# REPORT TO DESIGN COMMISSION City of Sacramento

**PUBLIC HEARING**  
**October 13, 2010**

**Subject: 3820 Broadway (P10-042)** Located at the southeast corner of Broadway and Martin Luther King Jr, Boulevard, a request to develop a three story 56 unit residential with ground floor retail on 1.2+/- acres in the Broadway/Stockton and Oak Park Special Planning District (C-1-SPD) zone.

# Trellis (@ MLK Blvd)

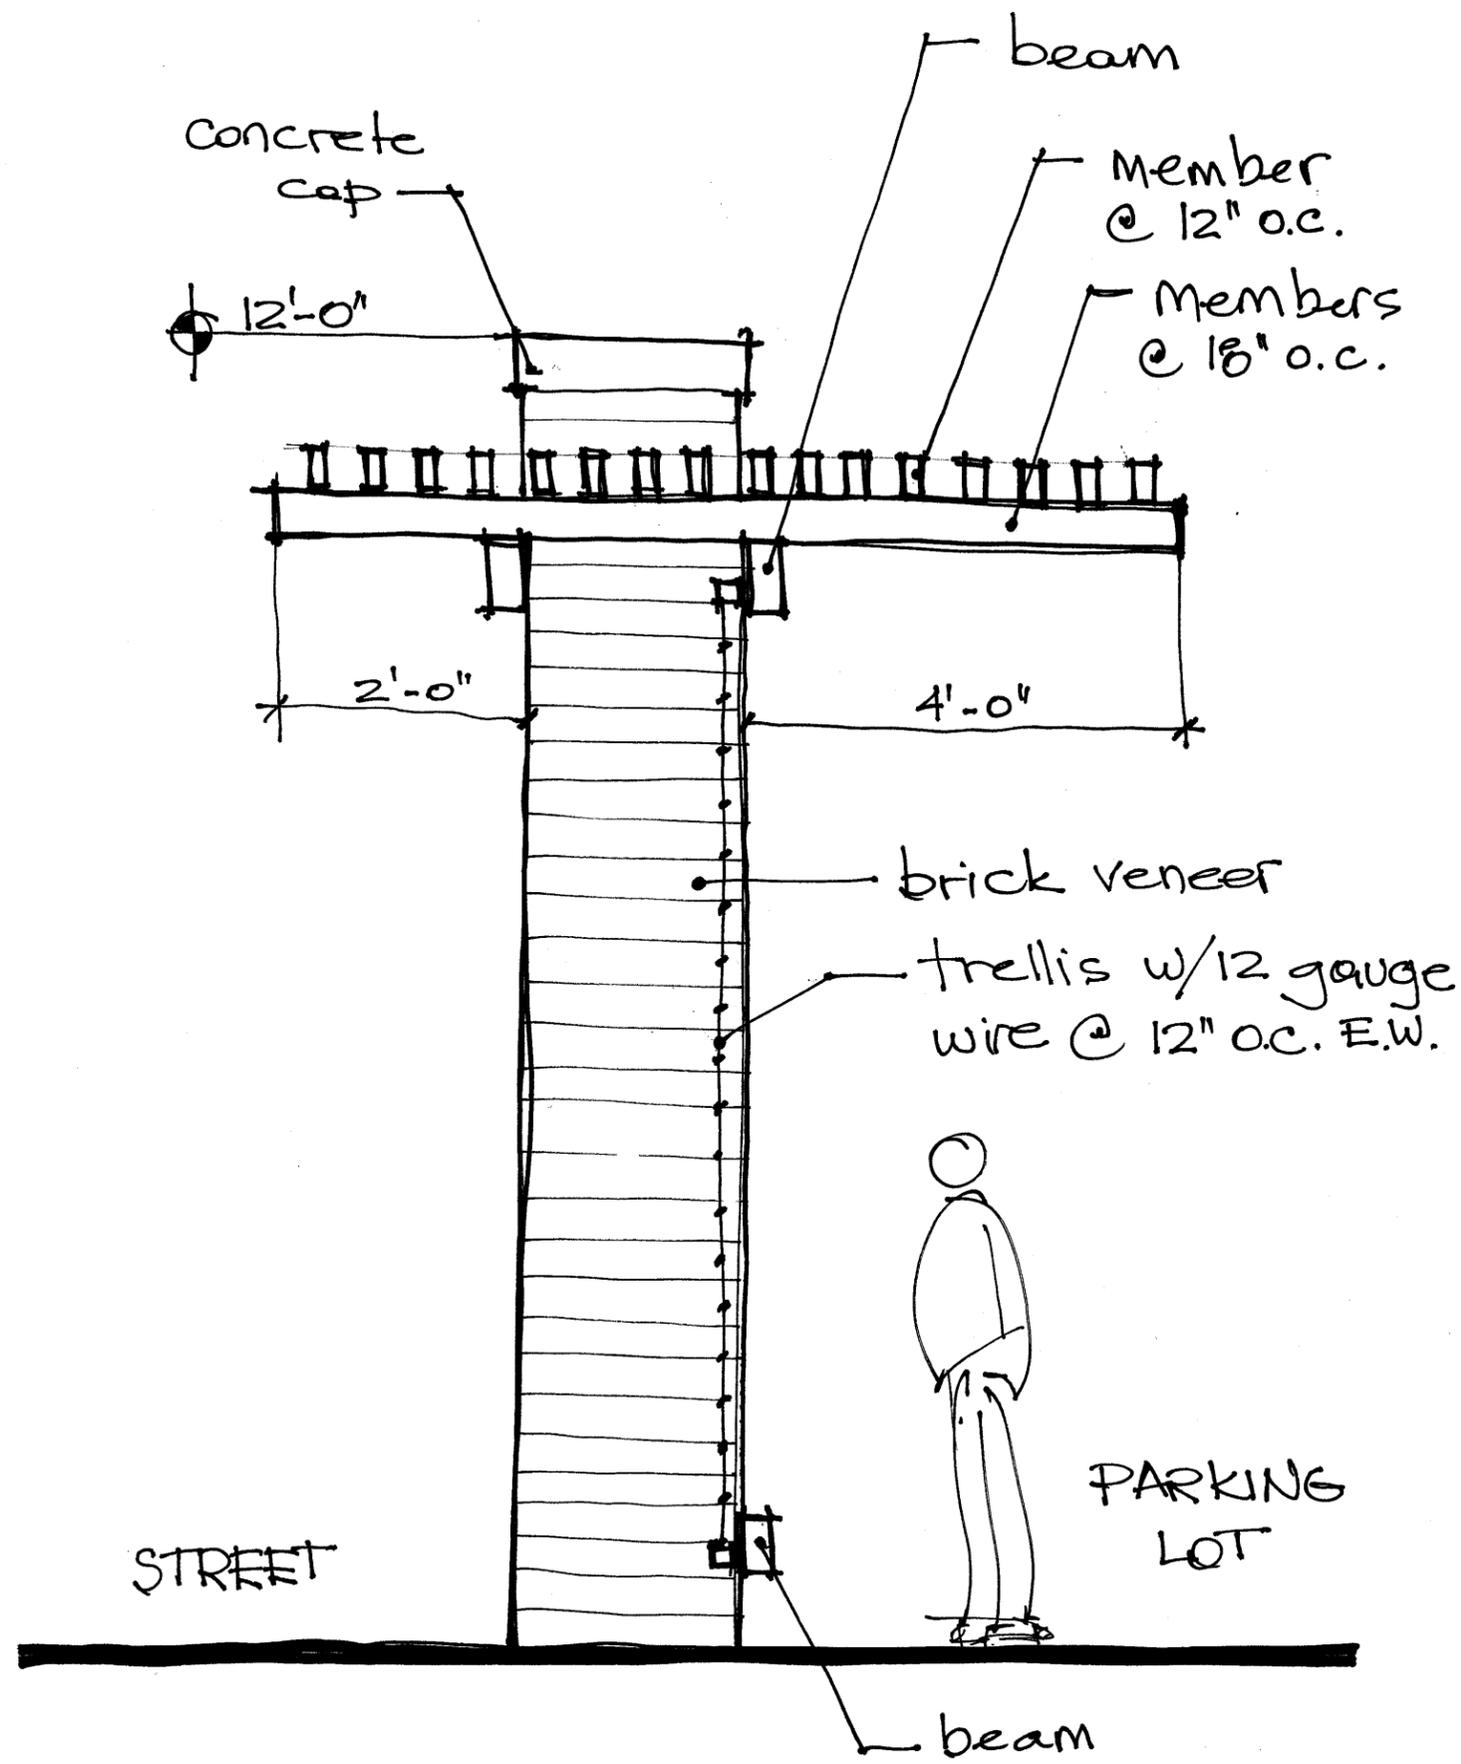
6. The trellis element has been placed closer to the street to allow additional room for site mechanical systems. Staff recommends relocating the double check valve behind the trellis element **where possible**, but should retain the Fire Department connection and post indicator valve at their present locations. The trellis element consists of brick columns with metal trellis and mesh for vines. **A trellis detail was provided for staff review, and staff supports the design with a few minor revisions. Staff recommends a different coursing at the top of the brick column instead of the proposed concrete cap, as it is introducing another material in a relatively small element that has plenty of material changes already. Detail drawings of trellis have not been provided for staff review, and should be provided for review and action by the Design Commission at the hearing.**

15. Site mechanical equipment, SMUD transformers, fire pump, etc. shall be located per approved plans. Backflow prevention devices and double check valves shall be placed behind trellis elements to minimize street and pedestrian views **wherever possible. The applicant shall submit final site mechanical locations for review and approval by Design Review staff prior to Building Permit submittal.**
